# service bulletin

No. 94-12

## A. EFI GASOLINE RECOMMENDATION CHANGES NUMBER 1 and 2

All 350, 454 and 502 cid EFI Stern Drive or Ski Inboard Engines

a. - "Check-Sum" Code Number Location.

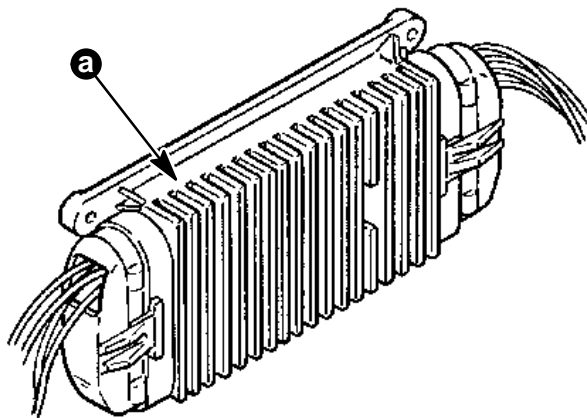
The use of unleaded regular or premium gasoline in these engines is acceptable. The newest ECM used on these engines will not do the "self spark sensor system test" each time the engine is started, like the older ECM's.

These newer ECM's will still retard spark and add more fuel if it detects a spark knock during its normal operation just as the older ECM's did.

All service replacement ECM's will have this latest change in them also. The "Check-Sum" code number placed on the latest ECM's that can use either regular or premium gasoline are as follows:

350 cid EFI engines: 983E

454 cid EFI engines: 93AB

502 cid EFI engines: 939D
